MONTGOMERY COUNTY HISTORIC PRESERVATION COMMISSION
STAFF REPORT

| Address: | 5 Columbia Ave., Takoma Park | Meeting Date: | 5/4/2022 |
| Case Number: | 988107 | Staff: | Dan Bruechert |
| Proposal: | Tree Removal, Hardscaping Alterations, and Accessory Structure Construction | | |

PRELIMINARY LANDSCAPE PLAN
 SCALE 1/4"=1'
 DECEMBER 11, 2021

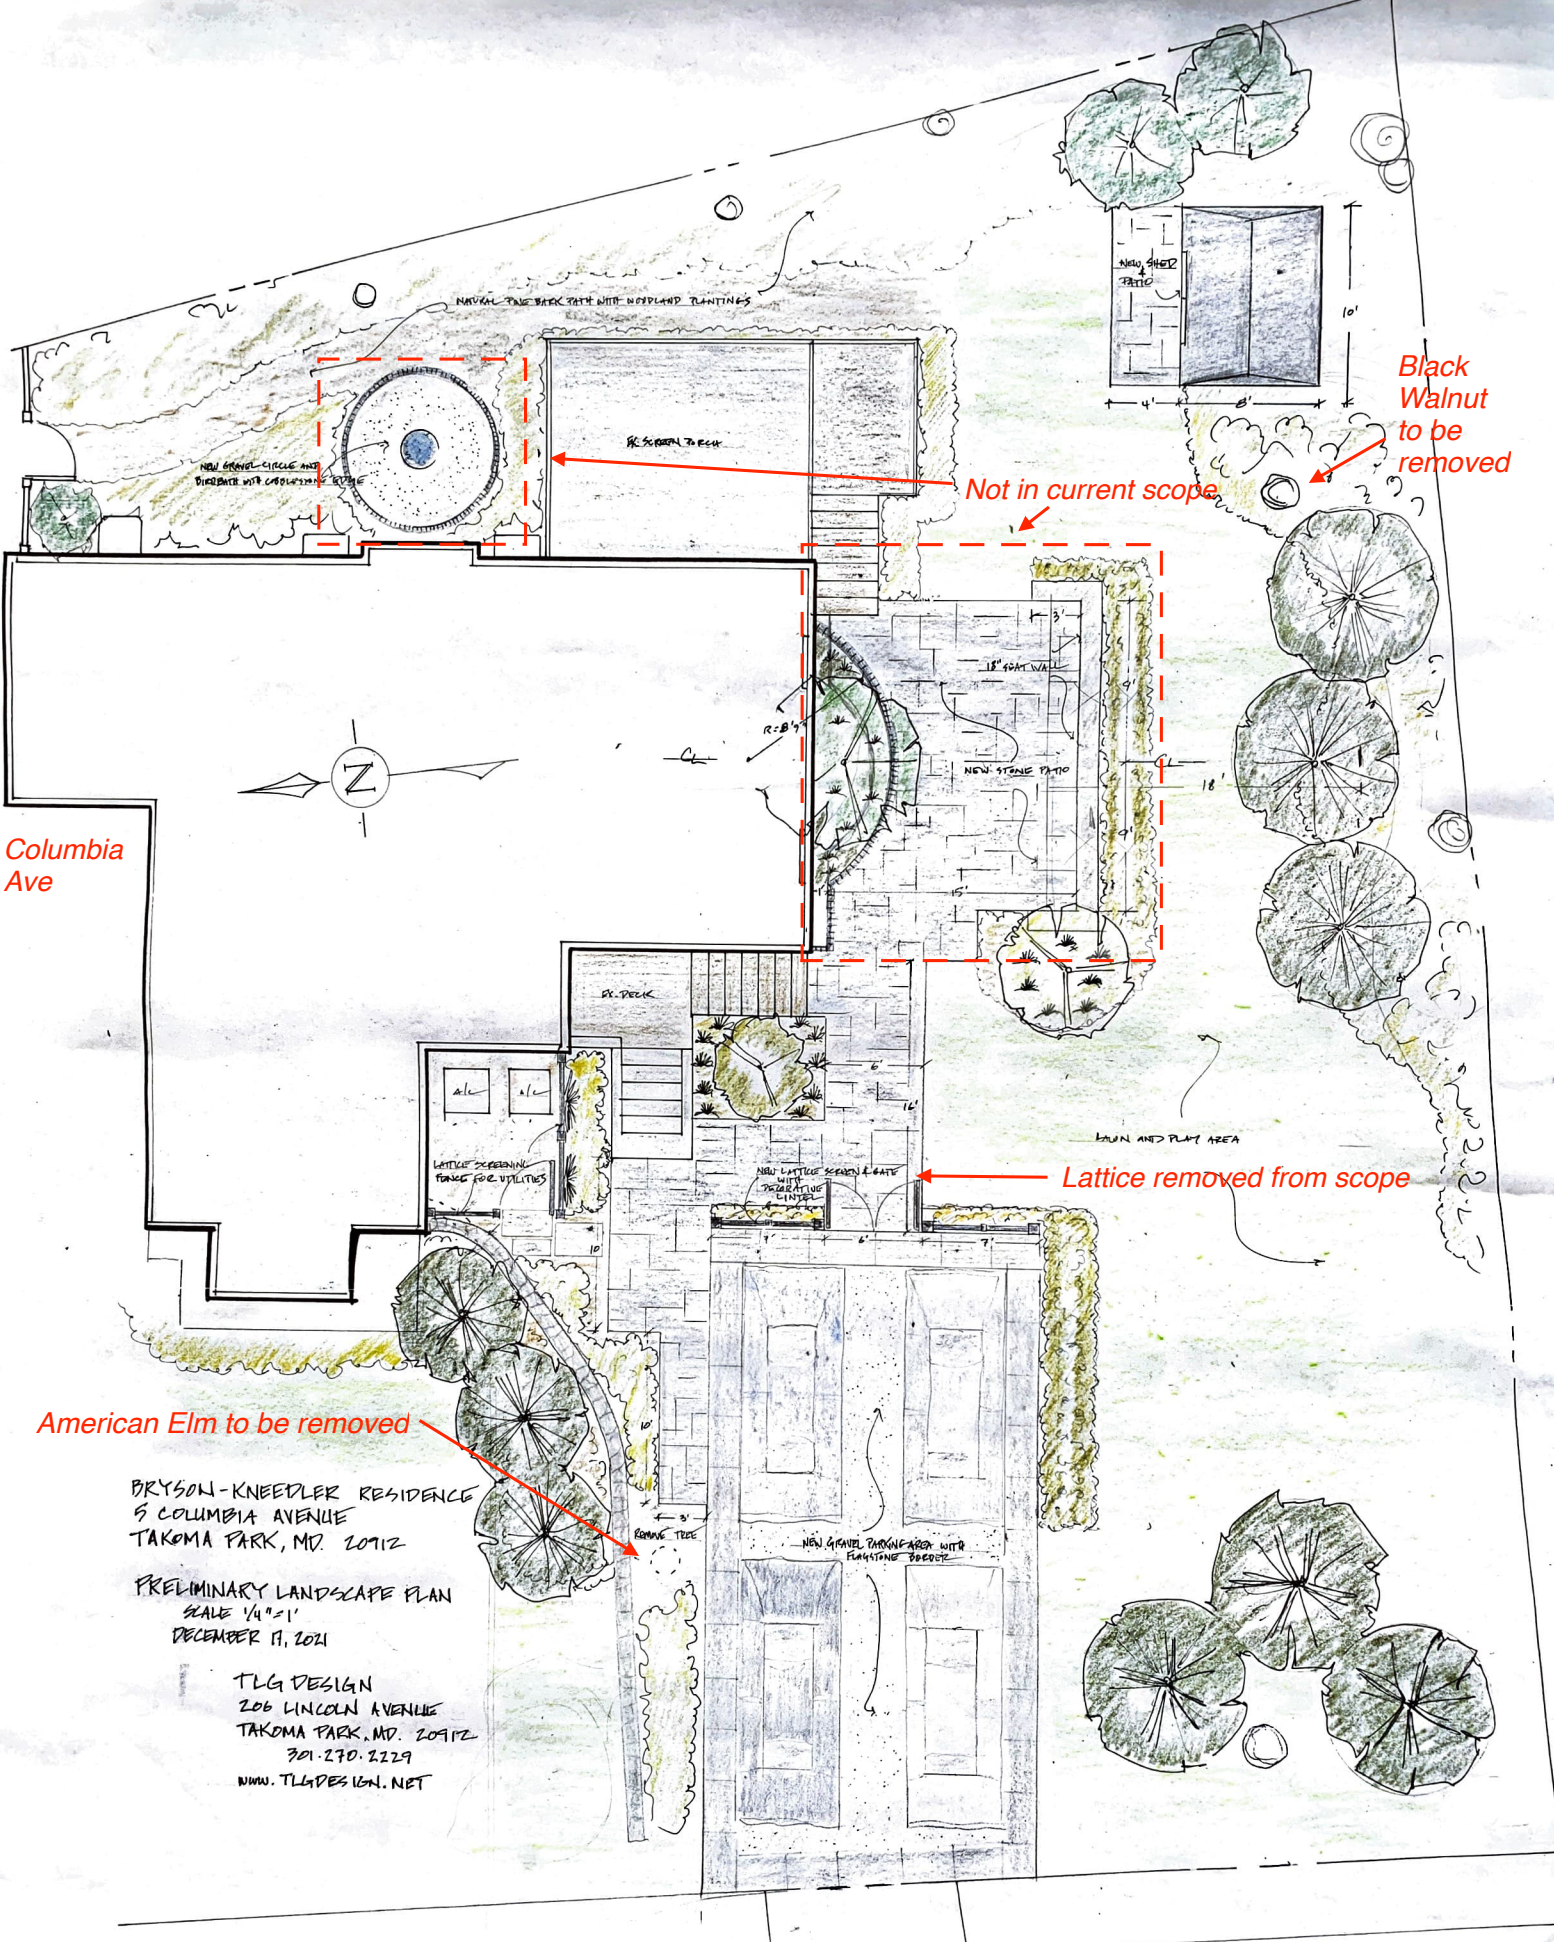
Staff finds the black walnut tree is towards the rear of the subject lot and its loss will not have a significant impact on the character of the site and the surrounding district. Staff finds removing the American elm will have a larger impact on the site because it is near Pine Ave. Staff notes the Takoma Park Arborist determined the tree's health was ranked as a 2 out of 5 (five being the healthiest), which is identified as "fair to poor health." The tree's health will continue to suffer as one-half of the root zone is covered by the existing parking area.

Staff finds these changes will not significantly impact the character of the site and surrounding district. First, the HPC has consistently found flagstones to be an appropriate material for walks and patios in the Takoma Park Historic District. While parking pads are generally disfavored in the district Staff supports one in this instance for a few reasons. First, there is a parking pad already on site, so that is the existing condition of the lot, not a new feature. Second, the proposal will not enlarge the existing parking pad, so the proposal will not increase the total parking area. And third, this parking pad is on the side elevation of the house, so it won't have the same visual impact as a parking pad adjacent to the façade—a condition that replicates modern suburban houses and is not typical of the era of the historic district. Staff finds the

Black Walnut to be removed

Lattice removed from scope

American Elm to be removed

Shed vendor: <https://www.ulrichlifestyle.com/sheds/>
 Style – The Heritage

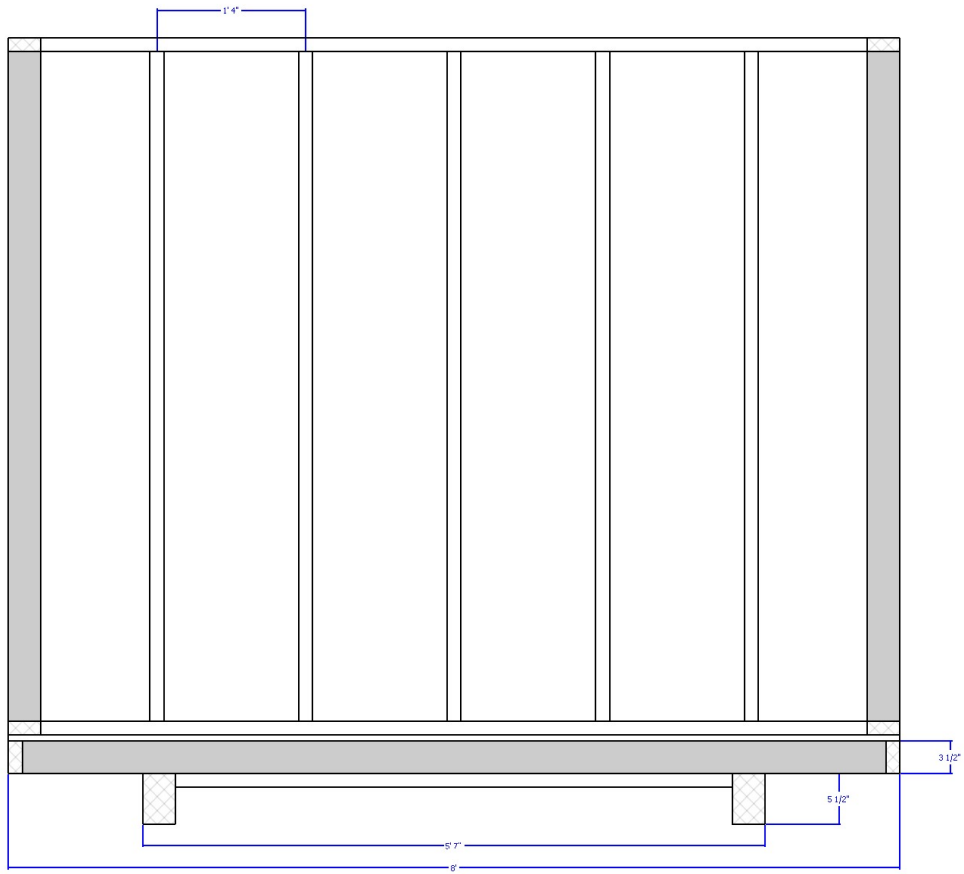
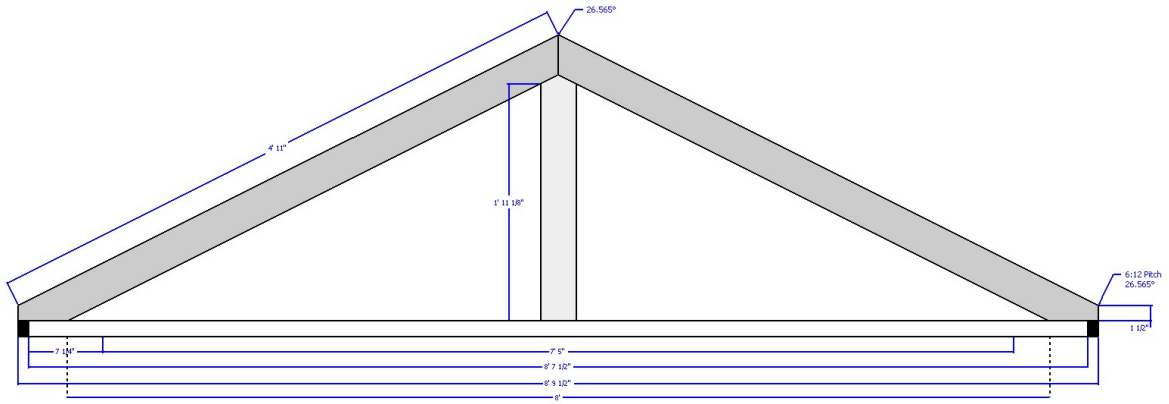
Staff finds the proposed shed will not overwhelm the house or surrounding district. Additionally, Staff finds the proposed materials are consistent with the building materials at the subject property and the surrounding district. Finally, Staff finds the proposed patio is an appropriate material that will not detract from the character of the site and will be only minimally visible from the public right-of-way. Staff recommends the HPC approve the HAWP under the *Design Guidelines*, 24A-8(b)(2) and (d), and Standard 2.
